INDESIT company

Model type:
AVXL88EU

Commercial code:
F029659

Fig. n10402231

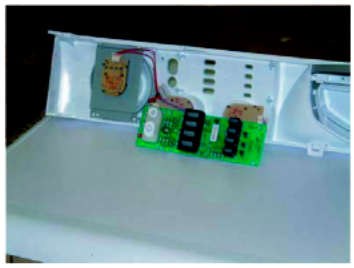
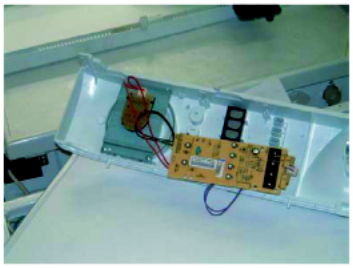
n1040331: Ariston LED restyling

From serial no. 40429.0001, models AVL, AVXL, AVSL, AML have been equipped with a new panel with well holes for the

ON/OFF and RESET buttons and flush plastic light diffusers in place of the projecting siliconed ones (see picture n10402231 Fig.02). These features determine whether an appliance is modified or premodification.
The modification has also involved the electronic card whose panel and display communication connectors are on the left and not at the back (see picture n10402232 Fig.2).

The codes affected by this modification are:

For both models
C00143338 - LED CARD EVOII AVL /BUILT-IN ARISTON
C00110115 - WHITE BUTTONS ON-OFF/RESET EVOII LED KIT
C00109854 - PANEL WIRING LBE EVOII
C00110055 - SILICONED BUTTONS AVL-AVSL
C00110059 - PANEL WIRING -DISPLAY 240000848B2.
C00111227 - WIRING MAIN - DISPLAY 24000084804B1 (POLARIZED).
The new parts are only interchangeable with the pre-modification ones if used altogether. They are not individually interchangeable.

This modification progressively involves all models of the Ariston Led range. The last two numbers of the Industrial Code for the modified models is 50 (e.g. 80299050050).

n1040381: Drain pump with bayonet-style filter - front Loading Brembate

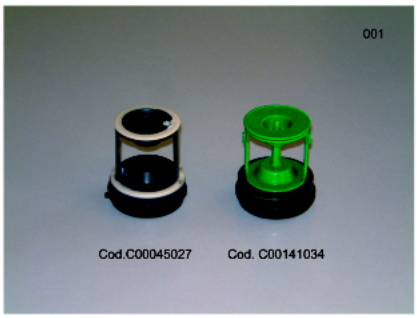
From serial no. 50720.0001 a new drain pump with bayonet-style filter has been installed on all front loading washing machines manufactured in Brembate.

New parts:
C00119307 - Drain pump
C00141034 - Pump filter kit

Premodification parts:
C00092264 - Drain pump
C00045027 - Pump filter kit

The new parts can be used instead of premodification ones.
